Hamilton Middle School SANITARY SEWER

Project Number
1210 PPS (607861)
CITY OF WICHITA, KANSAS
Michael E. Lindebak, P.E., City Engineer

AS BUILTS 11/24/02

Hamilton Middle School
Sewer Line 1
Wichita, Kansas

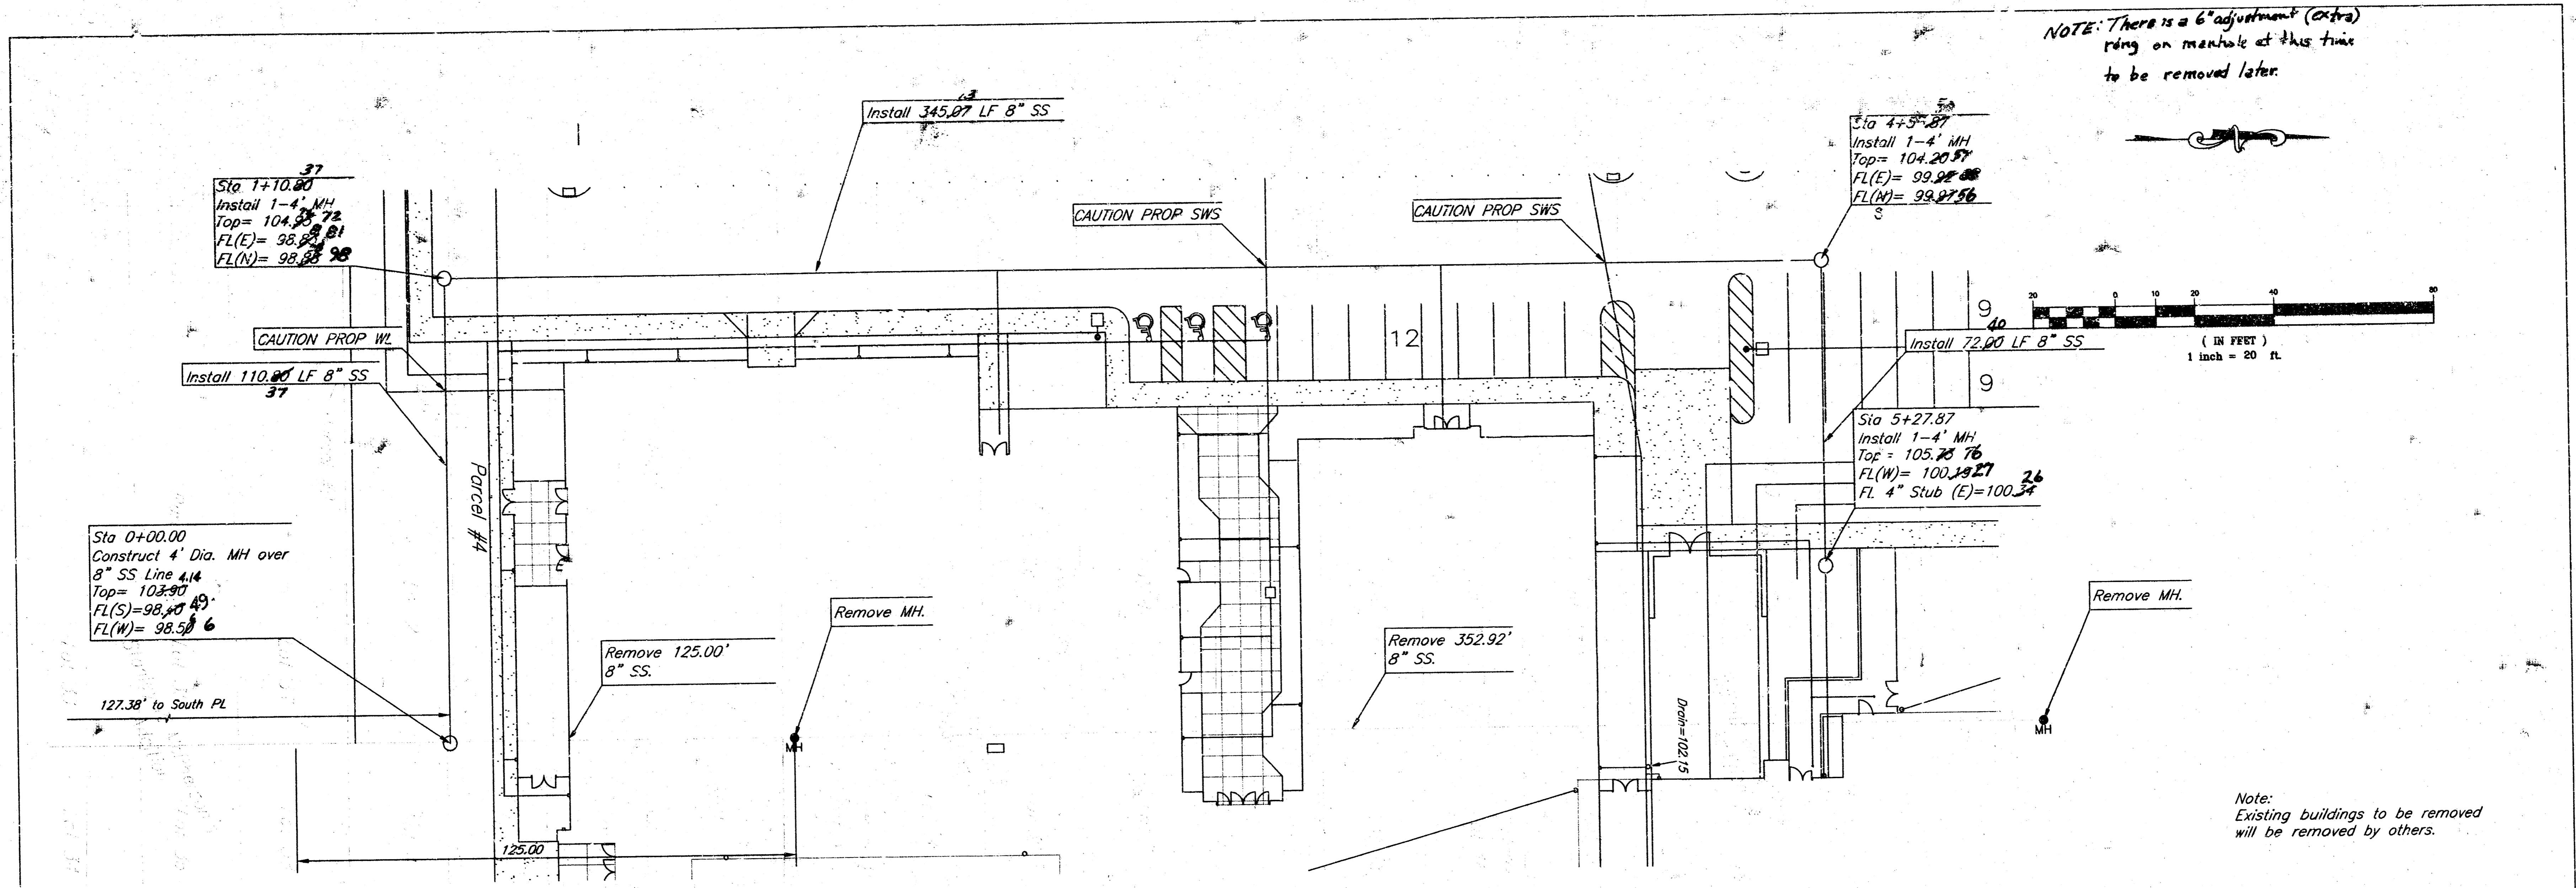
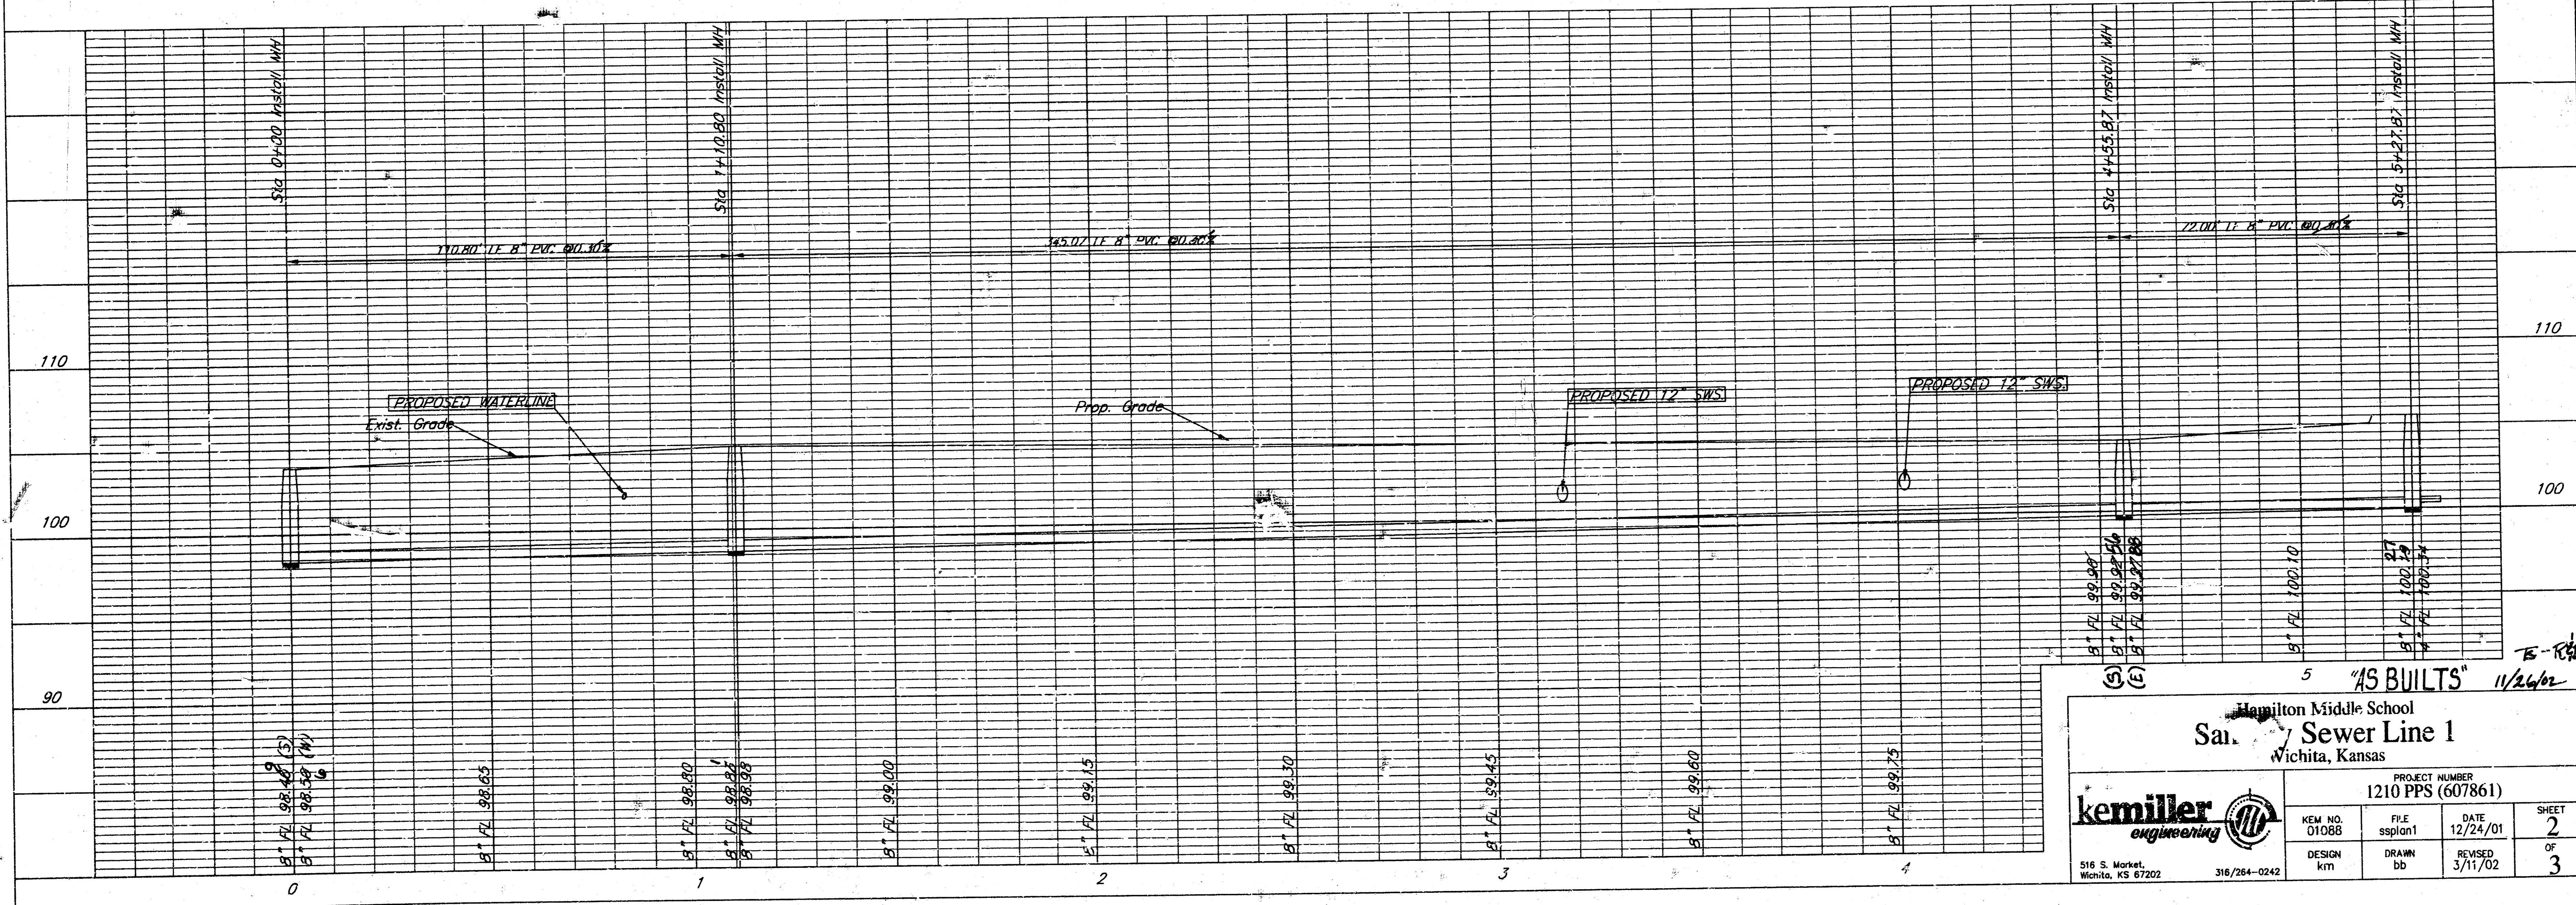
NOTE: There is a 6" adjustment (extra) ring on manhole at this time to be removed later.

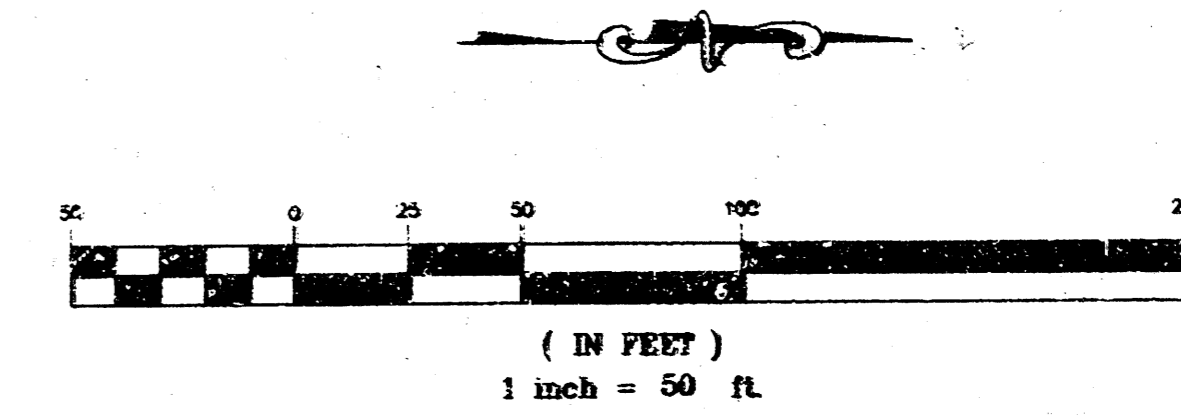
pipe Used SDR35
MH by WCP

Hamilton Middle School
Sanitary Sewer Line 1
Wichita, Kansas

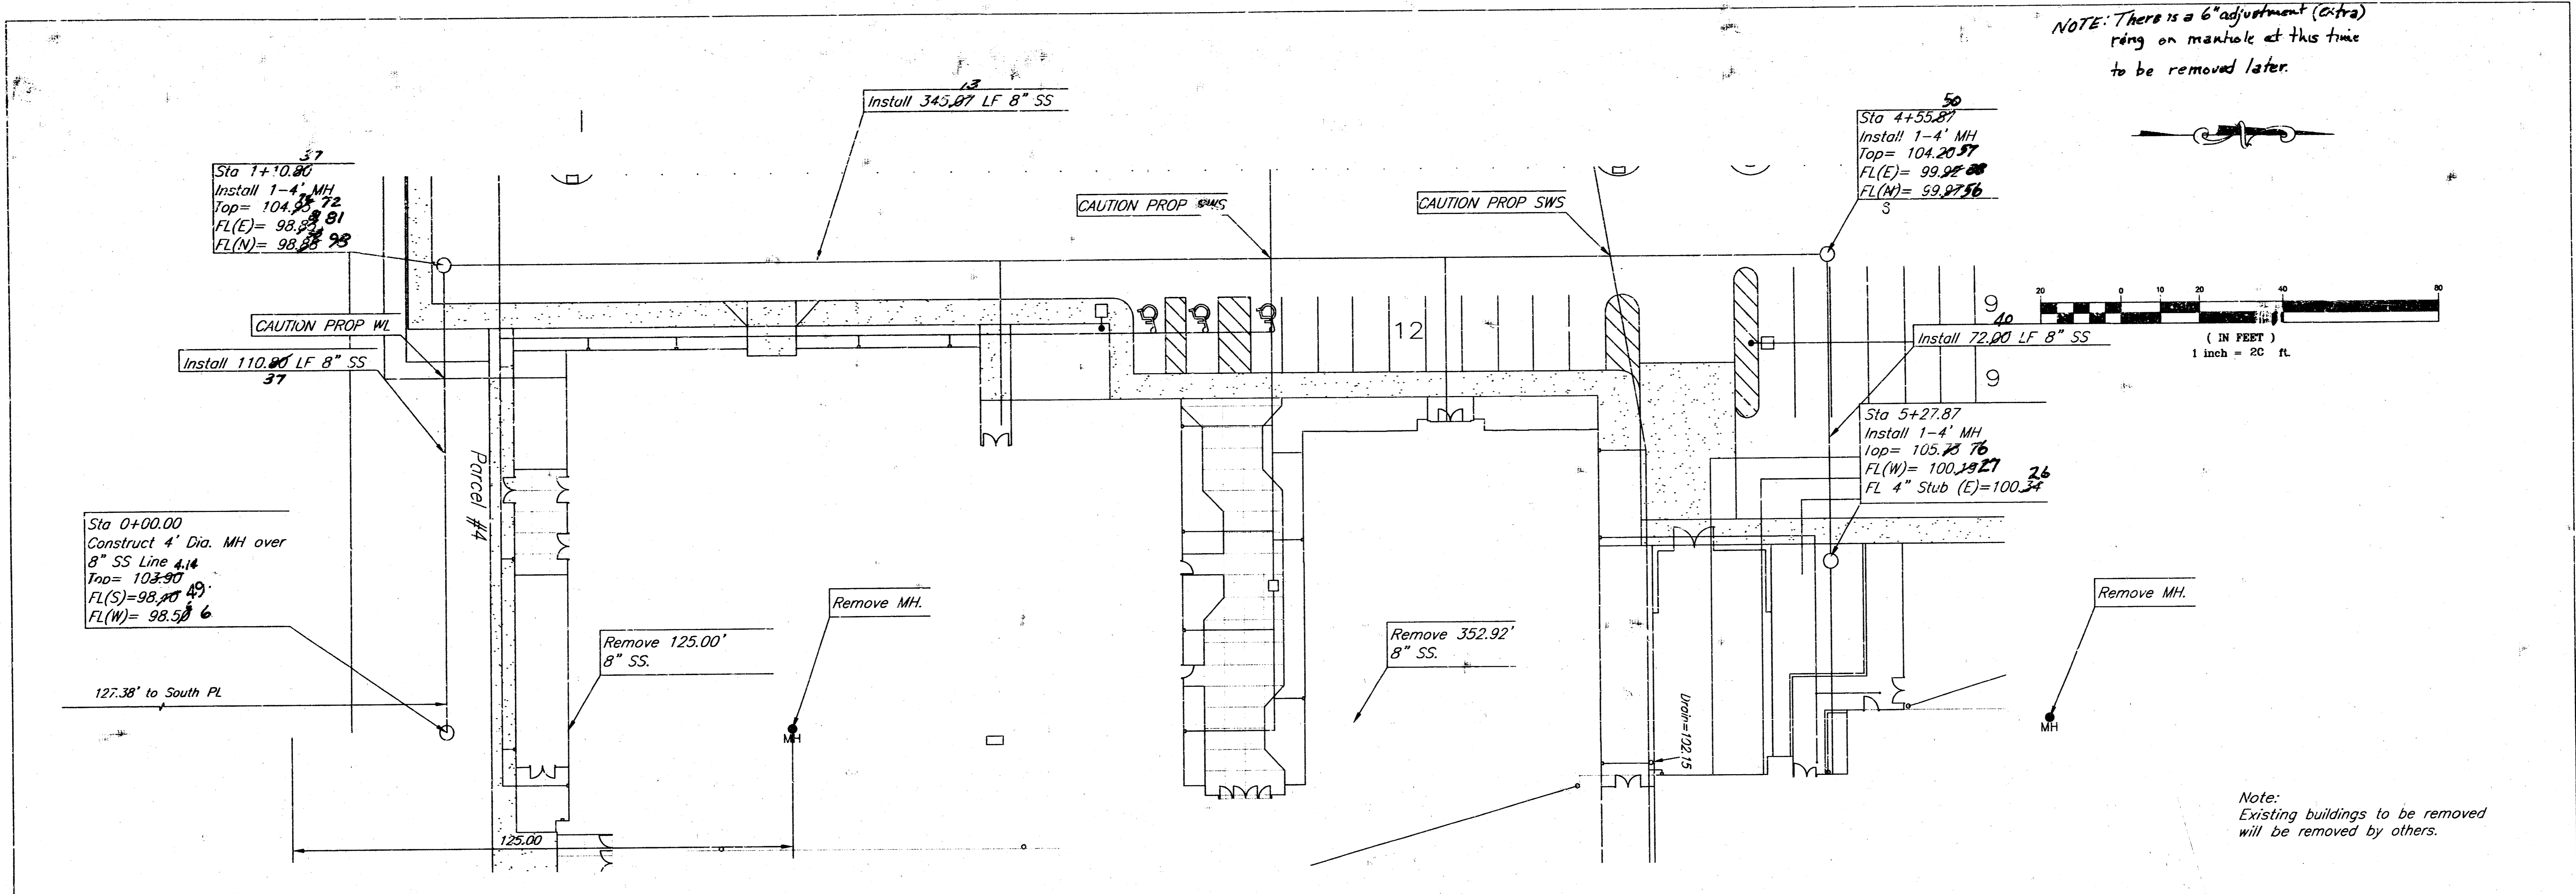
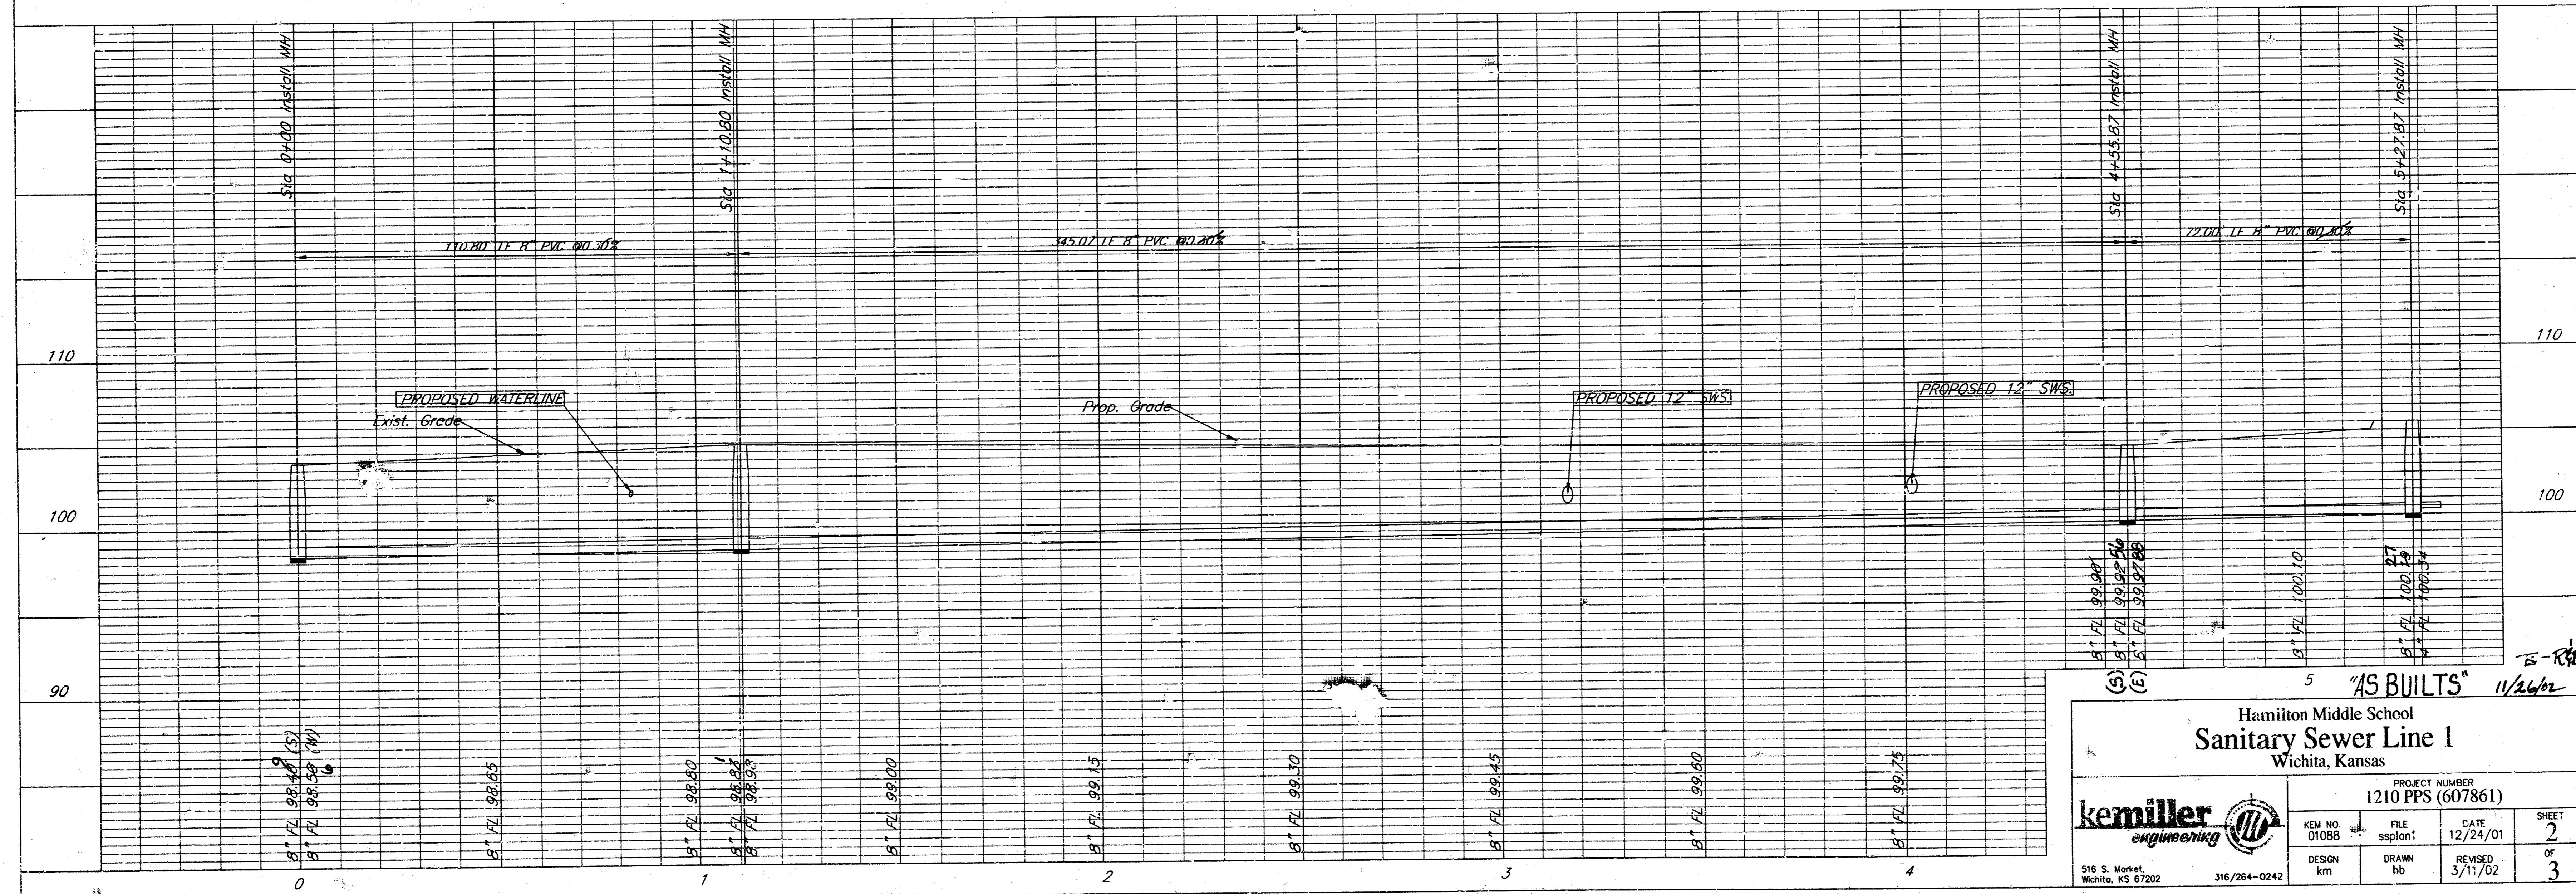
NOTE: There is a 6" adjustment (extra) ring on manhole at this time to be removed later.

AS BUILTS 11/26/02
